STAFF REPORT
COMMUNITY DEVELOPMENT DEPARTMENT

DATE: 10/21/2025
TO: City Council
FROM: Sonya Allen, Associate Planner
208-884-5533
sallen@meridiancity.org
SUBJECT: FP-2025-0009
District Ten Mile Subdivision No. 1

Final plat consisting of 17 buildable lots on 34.04 acres of land in the C-G zoning district for the first phase of District Ten Mile Subdivision.

FINAL PLAT OF DISTRICT TEN MILE SUBDIVISION

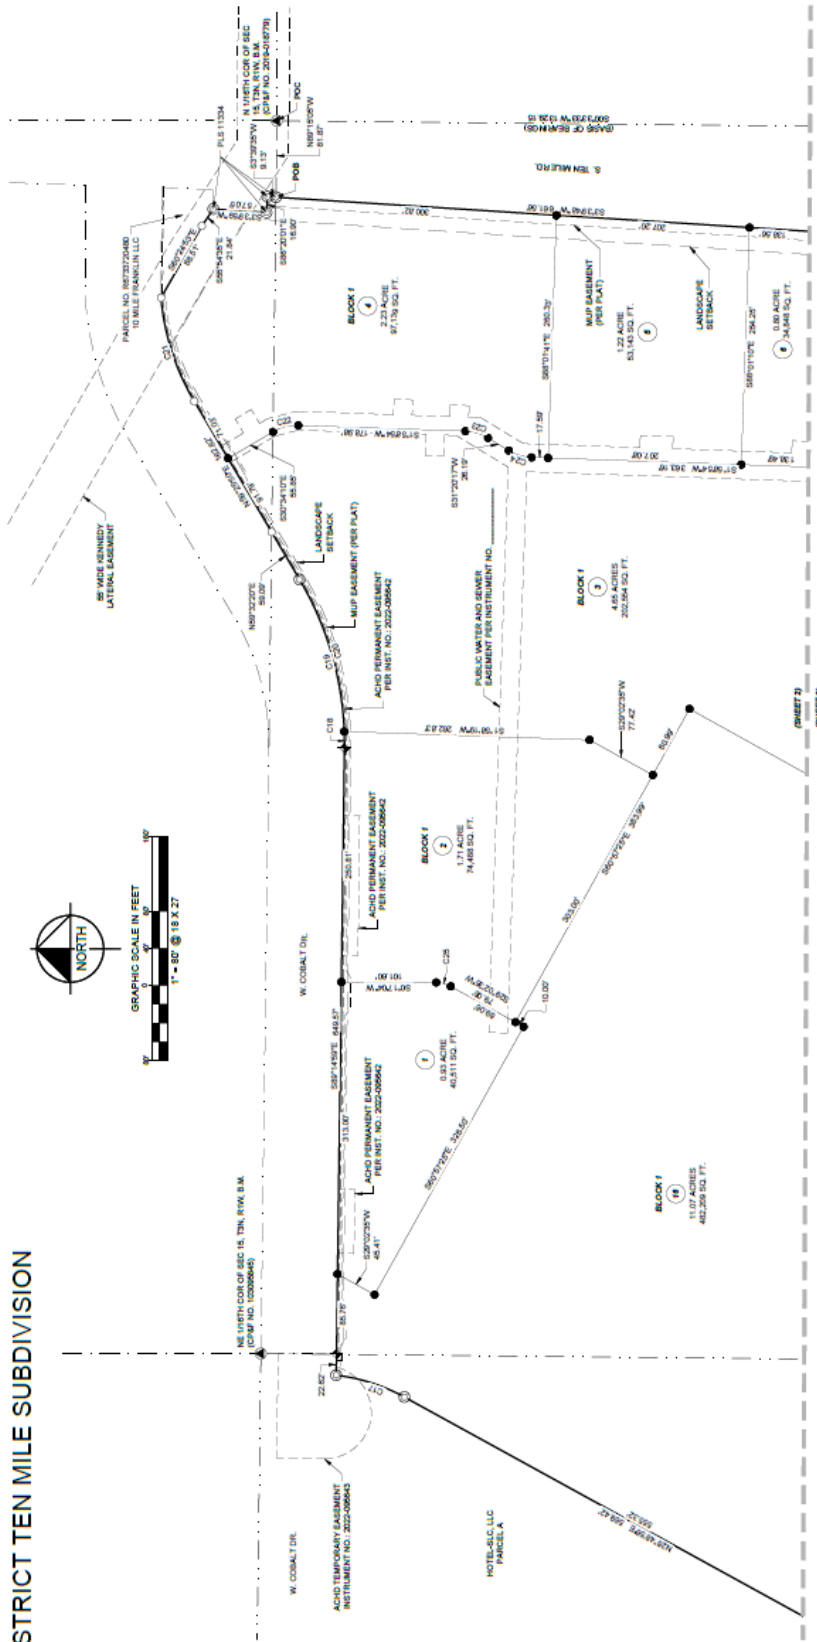
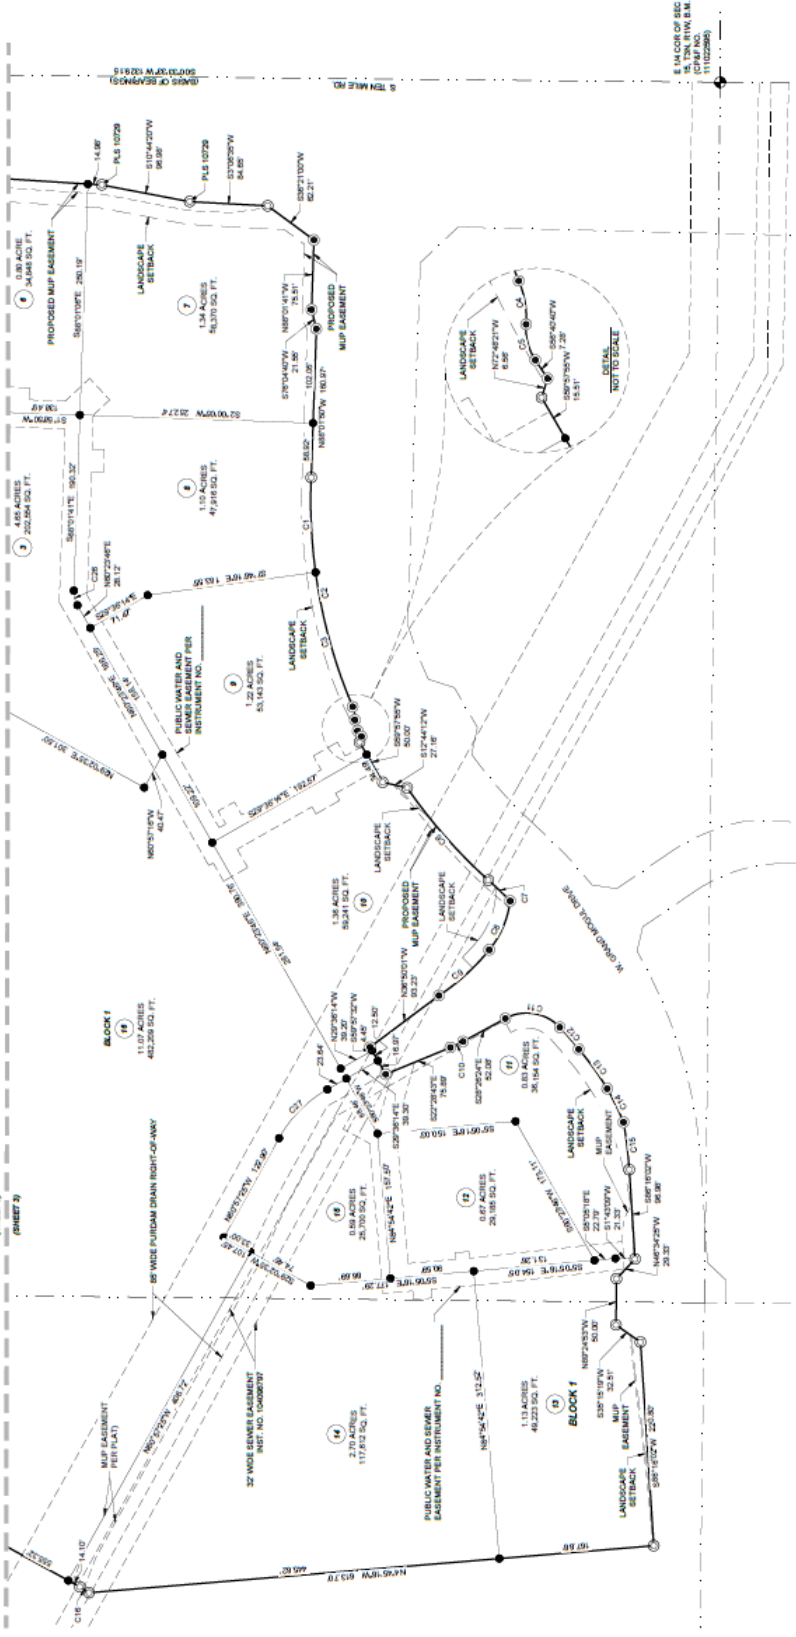
- a. Under Notes section on Sheet 4:
 - i. Note #3: Delete note in favor of note #5.
 - ii. Note #4: Include the recorded instrument of the CC&R's.
 - iii. Note #5: Include the recorded instrument number of the development agreement (i.e. #2023-022884).

- iv. Note #7: Complete missing information.
 - v. Note #11: Include the ACHD temporary license agreement instrument number.
 - vi. Note #12: Complete the missing information.

- vii. Note #13: Complete the missing information.
 - viii. Note #14: Complete the missing information.
 - ix. Note #15: Complete the missing information.

- x. Include a note stating who the responsible party is for maintenance of the street buffer landscaping along N. Ten Mile Rd., W. Cobalt Dr. and W. Grand Mogul Dr. (i.e. the property owner or business owner's association) in accord with UDC 11-3B-7C.2a.

- b. Include the phase number (i.e. No. 1) in the subdivision name.
 - c. Under the Surveyor's Narrative on Sheet 5, include the missing information in Note #2.

- d. Include the recorded instrument number of the public water and sewer easement graphically depicted on Sheets 2 and 3.
 - e. Depict 10-foot-wide detached sidewalks/pathways on the construction plans in the street buffers along N. Ten Mile Rd. and W. Grand Mogul in the areas where 6-foot-wide walkways are currently depicted near the intersections of Grand Mogul/Ten Mile and Cobalt/Ten Mile unless a physical barrier exists that prevents compliance. Submit a copy of the updated construction plans with the application for final plat signature.

- g. Include the recorded instrument number(s) for the multi-use pathway public use easement.
- 5. The landscape plan prepared by AO Architects, dated 7/18/25 included in Exhibit C, shall be revised as follows:
